SB-10058370-4020

FA15-003

2014-2015 ROGUE; POPPING NOISE FROM FRONT SUSPENSION WHEN TURNING

APPLIED VEHICLE: 2014-2015 Rogue (T32)

Figure 1

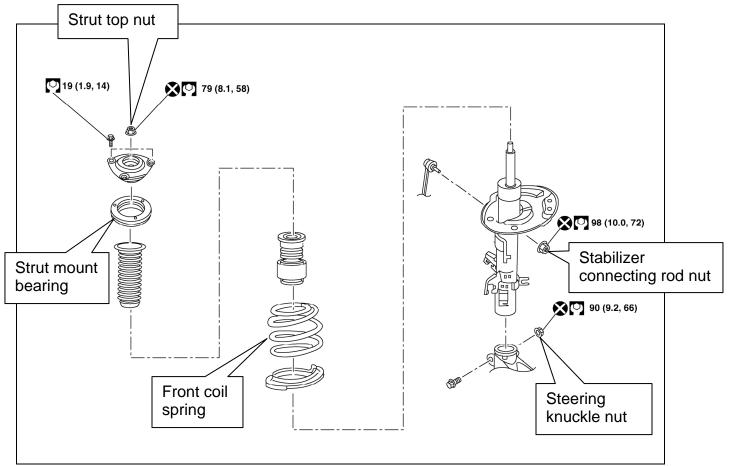
There is a popping noise from either the right or the left front coil springs when turning to the right or left.

Replace both the front left and front right coil springs, front strut bearings and single use nuts (Figure 1) with those listed in the Parts Information table on the next page.

DESCRIPTION	PART #	QUANTITY
Front Coil Spring (FWD vehicles)	54010-9TA0A	2
Front Coil Spring (AWD vehicles)	54010-9TA1A	2
Strut mount bearing	54325-8271R	2
Steering Knuckle Nut	01223-N2011	2
Strut Top Nut	54588-JA005	2
Stabilizer Connecting Rod Nut	04000-JAUU0	2
